GENERAL CONSTRUCTION PERMIT: ACTION LEVELS AND NUMERIC EFFLUENT LIMITS ANALYSIS

RECOMMENDATION OF ALTERNATIVES

Prepared for
California Building Industry Association (CBIA)
1215 K Street, Ste. 1200
Sacramento CA, 95814

Date June 24, 2009
FSI 077026.2

Figure 1. Hourly pH in the Trinity River near Weitchpec. The station (WPC) is located at latitude 41.179 and longitude -123.706. pH data (N=11,864) are available only from 05/05/2005 to 10/04/2005. Source: <http://cdec.water.ca.gov>.

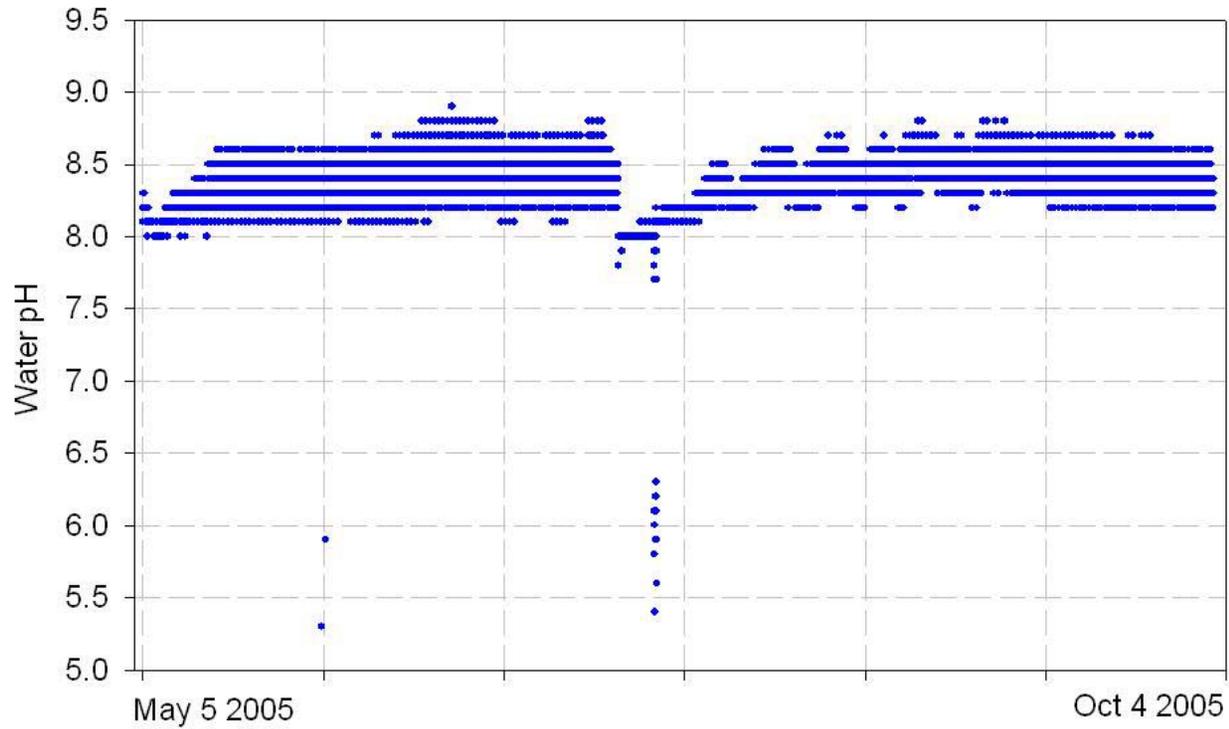
ranges as high as 8.9 in the Trinity River near Weitchpec (see **Figure 1** and Section 4 and Table 18 at p. A-20 of Flow Science (2008)) and 9.5 in San Diego Creek (see p. A-23, Flow Science (2008)). Because of regional variations in natural or background pH levels, it is inappropriate to apply a uniform NEL statewide. Where natural or background pH levels fall outside or at the margins of the proposed NEL range, the NEL should not apply.

Figure 2. pH of precipitation for November 26 - December 23, 2001. Obtained from <http://water.usgs.gov/nwc/NWC/pH/html/ph.html>.

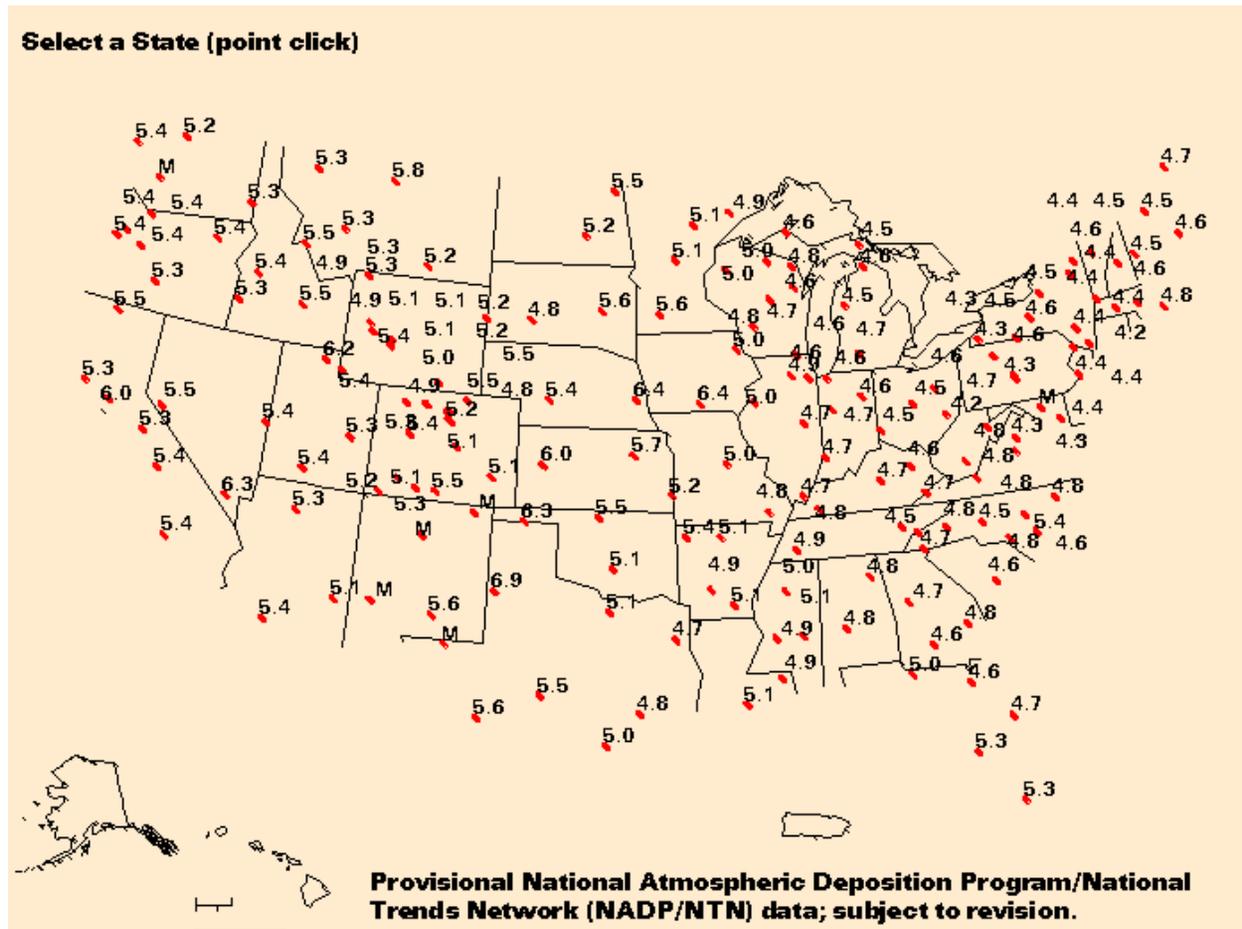
- **The pH of rainfall falls outside the proposed NEL.** Data collected by the U.S. Geological Survey (USGS) indicate that rain in California has a long-term average pH that varies between 5.3 and 6.0, depending upon location (**Figure 2**). For individual storms, pH values as low as 4.5 have been observed (see, e.g., <http://nadp.sws.uiuc.edu/ads/2003/CA45.pdf>). If storm water runoff includes water that has not had significant contact time with soil or earth, it is possible for runoff pH values to be low and outside the range of the NELs. Samples with a pH value below 6.0 (i.e., below the NEL) should not be considered to constitute violations of the permit if insufficient contact time with the ground surface is the cause of the exceedance.

Figure 3. EPA level III ecoregion map with median suspended sediment concentrations (mg/l) for ecoregions 6 and 14 from Simon et al. (2004).

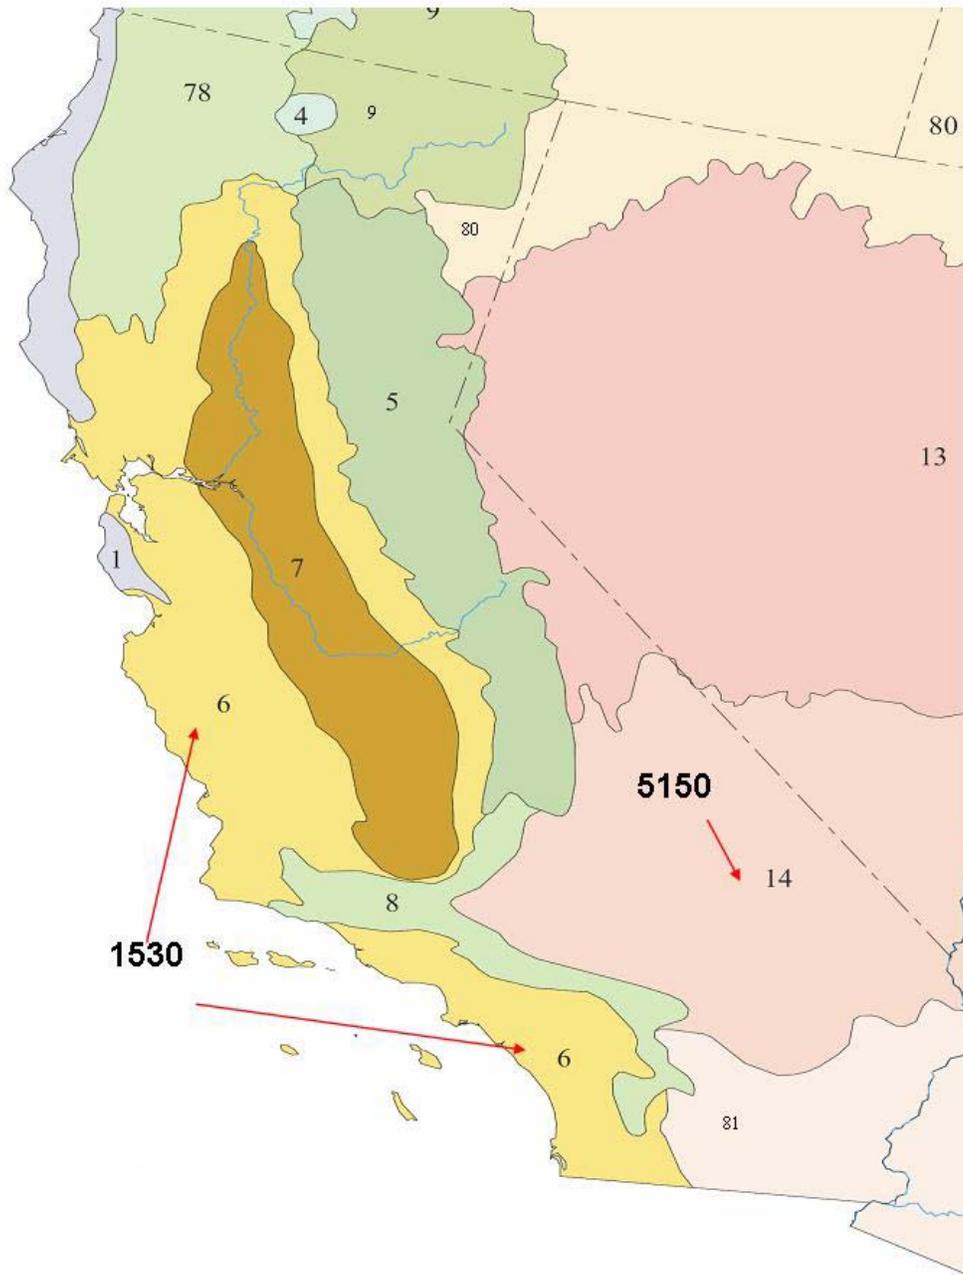
- **The eco-region data used for the development of the NEL for turbidity are limited and not appropriate for the purpose of NEL development.** Data from Simon et al. (2004) are not sufficient to support an NEL. Simon et al. (2004) present estimated suspended sediment concentrations (SSC) that are median values for 1.5-year flow events; these data are provided “*for the purpose of defining long-term transport conditions*” of sediment. The Simon et al. (2004) dataset do not characterize event-scale variability, even though data for individual storms will be used to assess compliance with the NEL. Even using staff’s estimate of 1:3 for turbidity:SSC (which is faulty, as described below), more than 50% of the data in over 40% of the State would greatly exceed the NEL. For example, *median* values of SSC in ecoregions 6 and 14 for a 1.5-year flow event are 1530 and 5150 mg/l, respectively (**Figure 3**). The state-wide “area-weighted average” median SSC concentration provided in the draft Fact Sheet (p. 16) is 1633 mg/l, which is likely greater than the proposed NEL of 500 NTU, and indicates that approximately 50% of samples from across the state would exceed the proposed NEL. In addition, the ecoregion data clearly indicate that some regions of the state experience greater erosion than others. For example, the median SSC concentration from ecoregion 5 (8.8% of California’s land area) is 35.6 mg/l, while the median SSC concentration from ecoregion 14 (21.7% of the State’s land area) is 5150 mg/l. These data indicate that a blanket, “one-size-fits-all” NEL is inappropriate for the State.

- **Numerous studies demonstrate that turbidity in receiving water often exceeds the NEL of 500 NTU.**
 - As discussed above, the median suspended sediment concentrations (SSC) for 1.5-year recurrence interval flows for each ecoregion in CA range from 35 to 5150 mg/l (p. 16 of the draft Fact Sheet). Median SSC for the two biggest ecoregions (6 and 14) exceed 1500 mg/l SSC, indicating that they would exceed the NEL of 500 NTU using the 1:3 SSC:NTU formula proposed by SWRCB staff.

Figure 4. General locations of four sites where statewide Regional Water Quality Control Board enforcement data were collected. Map prepared by URS.

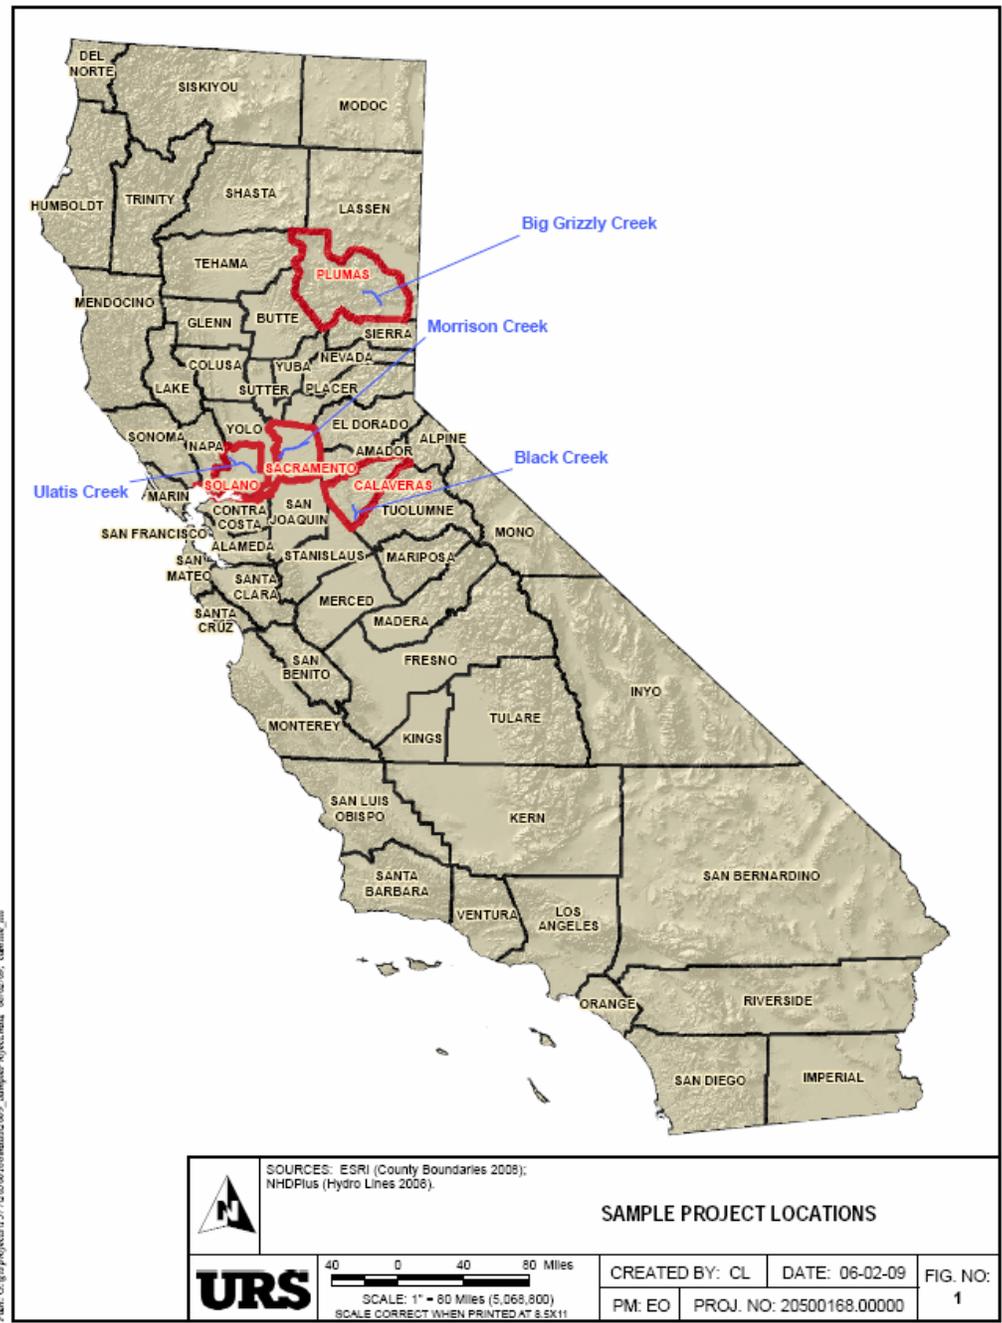
- **The enforcement data used to develop the turbidity NEL are not representative.** The enforcement data cited in the draft Fact Sheet (p. 15) include one data point from each of four construction projects located within one region (Central Valley Region) of California. As shown in **Figure 4**, these projects are located in the northern part of the state and are not representative of conditions in the more arid environments of southern California or of a broad range of soil types. The hydrologic conditions under which the data were collected (e.g., rainfall amount, storm intensity) are unknown, and the conditions that led to Regional Board enforcement at these locations are not specified by SWRCB staff in the draft Fact Sheet. Further, the values of these four data points range from 1400-1800 NTU, so that it is unclear how these numbers were used to derive the turbidity NEL of 500 NTU.

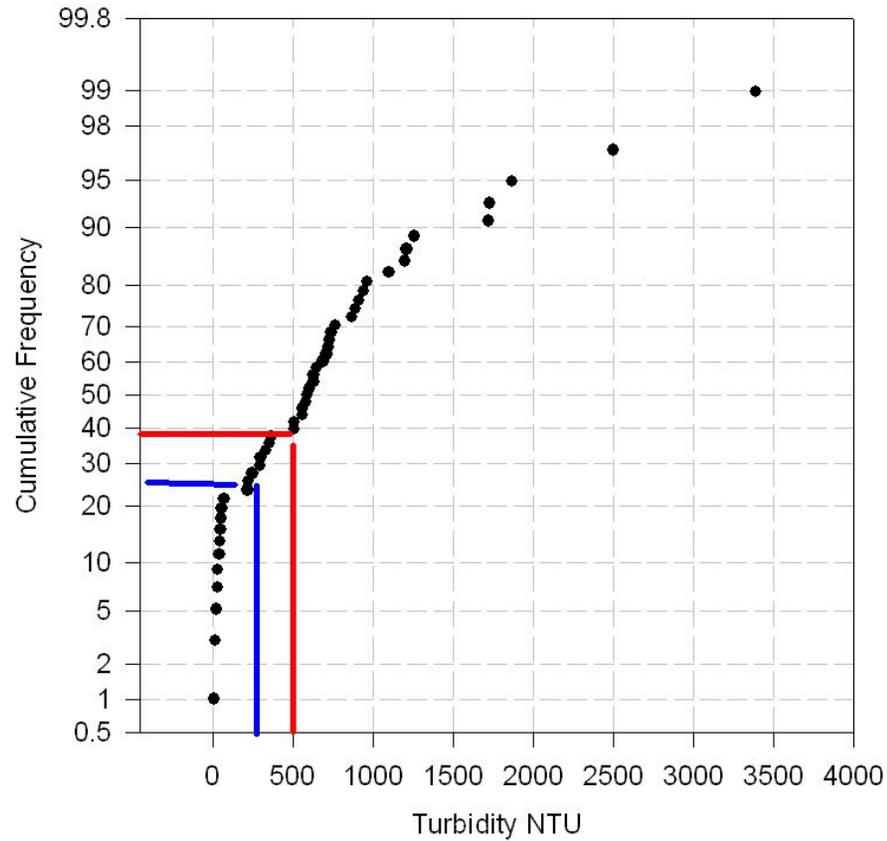
- Caltrans monitoring data for turbidity show that “typical construction site runoff” in California ranges from 15 NTU to 16,000 NTU (Caltrans 2002). Available Caltrans data from 1999-2002 show that 60% of data exceed the proposed NEL of 500 NTU (**Figure 5**). Note that staff used Caltrans data only for the development of the pH NEL (not for development of the turbidity NEL), and only a summary of 1998 turbidity data are provided in the 2002 Caltrans report. Still, these data clearly indicate that an NEL of 500 NTU does not represent an “*upset value, which is clearly above the normal observed variability,*” as recommended by the Blue Ribbon Panel (p. 17 of Blue Ribbon Report, emphasis added).

Figure 6. Ratios of total suspended solids (TSS, mg/l) to turbidity (NTU) in storm water samples (1992-2006) collected by Orange County. Source: http://www.ocwatersheds.com/StormWater/documents_damp_pea.asp.

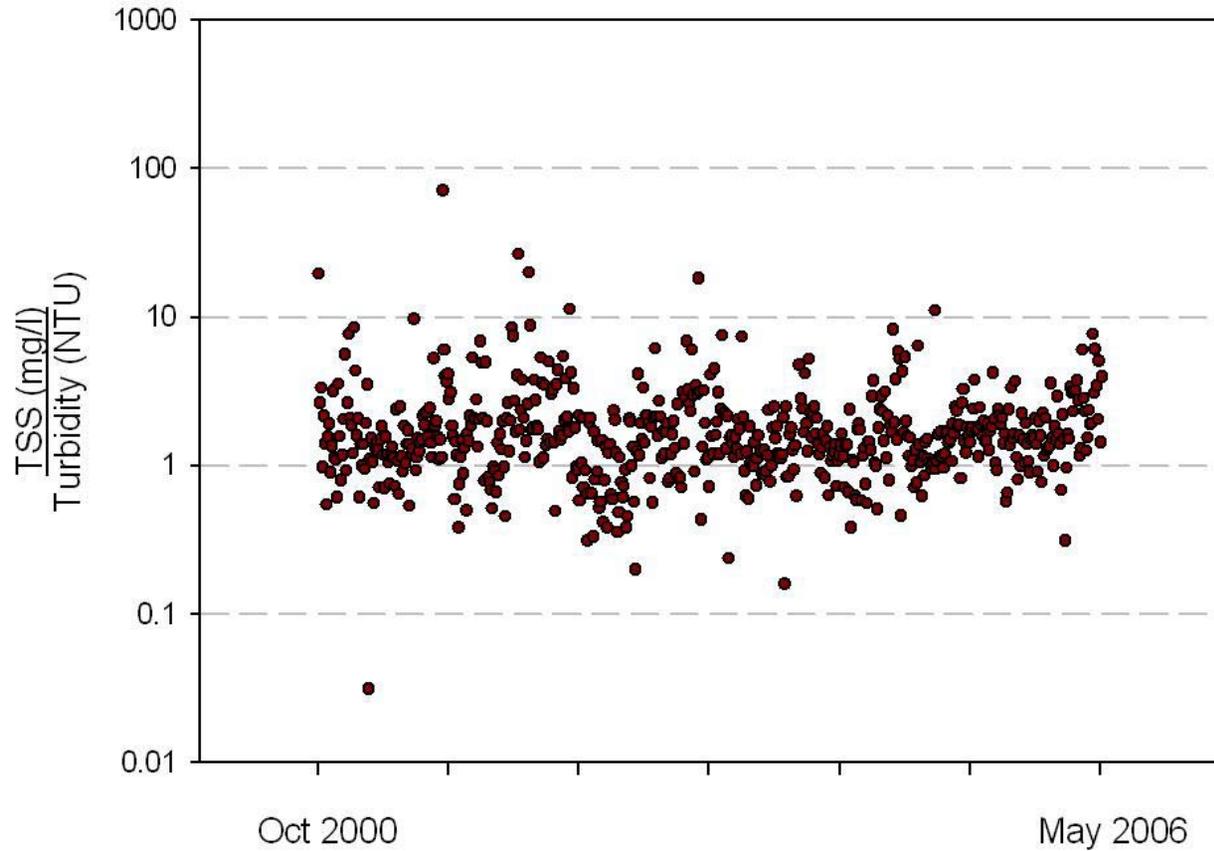
- **No scientific basis exists for the 1:3 relationship between turbidity (NTU) and suspended sediment concentrations.** As noted above, SWRCB staff assumed a 1:3 relationship between turbidity (NTU) and suspended sediment concentrations (i.e., assumed that 3 mg/l SSC was equivalent to 1 NTU). This assumption is erroneous. NTU: TSS ranged from 1:0.8 to 1:2.2 in data collected by USEPA for “Environmental impact and benefits assessment for proposed effluent guidelines and standards for the construction and development category” (USEPA 2008). Although several authors have attempted to correlate turbidity measurements with gravimetric measurements of suspended sediment (Schroeder et al. 1981; Schubel et al. 1978; Schubel et al. 1979), a consistent relationship has not been established. Correlations are generally site-specific and may change over the course of a year, although not in a consistent fashion (Manka 2005). The suspended sediment-turbidity relationship shifts between the rising and falling limbs of the hydrograph (Knighton 1998). Variability in the suspended sediment-NTU correlations can be attributed to differences in size, composition, and refractive index of particles (Earhart 1984). For dilute solutions, there appears to be a linear relationship between the amount of light scattered and the amount of suspended material, but when suspended sediment levels are high, light cannot penetrate the sample and will distort the turbidity reading (Schubel et al. 1978). Data presented in these references indicate that the NTU:sediment ratio can vary from 1:0.014 to 1:33, indicating that the assumption that a constant 1:3 relationship exists between turbidity and TSS is suspect and represents a serious oversimplification. For instance, event-based storm water data from Orange County storm water monitoring programs from 1992 through 2006 demonstrate that the ratio of sediment concentrations (measured by Orange County as total suspended sediment) to turbidity (NTU) varied over two orders of magnitude (**Figure 6**). In conclusion, it is problematic to use any one fixed ratio for the relationship between turbidity (NTU) and suspended sediment concentrations.

Figure 7. Ratios of suspended sediment concentration (SSC, mg/l) to turbidity (NTRU) in data collected from USGS stations from October 2007 to August 2008. Source of data: <http://waterdata.usgs.gov/usa/nwis/sw>.

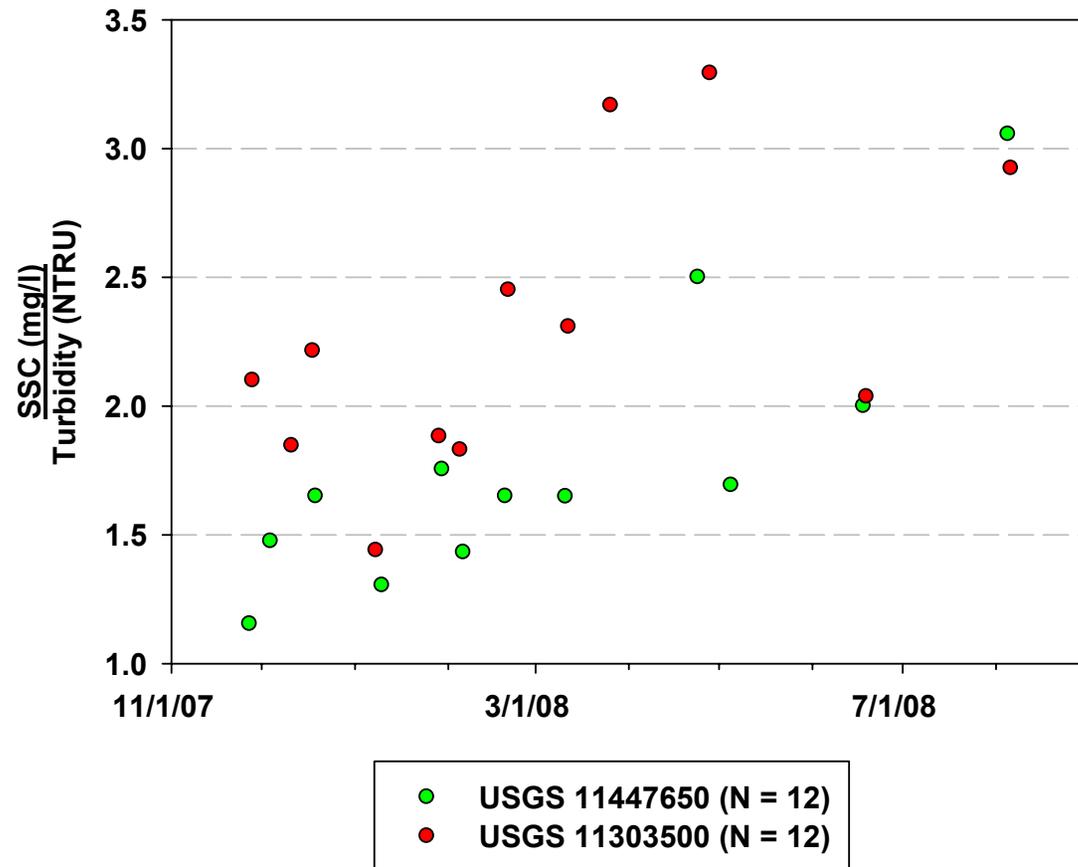
- **The calculation of 1:3 using the USGS data is faulty.** It is unclear that how the 1:3 ratio for NTU:SSC was calculated using data from three USGS stations (p. 15 of the draft Fact Sheet). Of these three USGS stations, we were unable to locate any turbidity data for USGS station 11074000. Water-data reports 2008 for USGS stations 11447650 and 11303500 contain a total of 24 data points where both turbidity (NTRU³) and suspended sediment concentrations (mg/l) were collected on same dates. Note that turbidity data available from these USGS stations are in NTRU instead of NTU. Staff does not provide any explanation how NTRU values were converted to NTU values. Nonetheless, these limited USGS data demonstrate that ratio between NTRU and SSC ranges from 1.1 to 3.3, with a median value of 1.86 (**Figure 7**).
